Item	Date	Source	Comment	Response
D01	11/13/2019	Post-it	Consideration for Pedagogical Approach	Noted. Specific recommendations may be made.
D02	11/13/2019	Open Comment	Tobin is Montessori and Vassal isn't – how is this worked into classroom design	We have met with the teachers from all programs, including the Tobin, Vassal Lane and the Department of Human Services Programs, on multiple occasions to define their needs and are also drawing upon our experience in designing for Montessori programs and co-teaching models. Detailed classroom designs will be developed as the design develops.
D03	11/13/2019	Open Comment	Can the site handle the mix of programs? Can the city rethink to having all elementary and moving the other programs? Has there been any other sites studied for the new preschool?	
D04	11/13/2019	Open Comment	Strong push for city council and school department to address all the four year olds

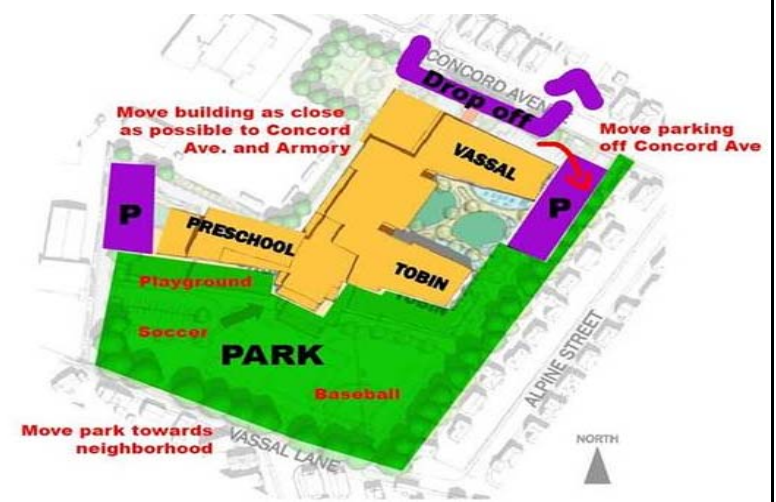
P19	11/13/2019	Post-it	I feel the combo soccer / baseball field won't work / be nearly as useful as hoped. Do one really well. Not two poorly.	
P20	11/13/2019	Post-it	Full size Soccer Field	The soccer field shown is sized for U-12 and under.
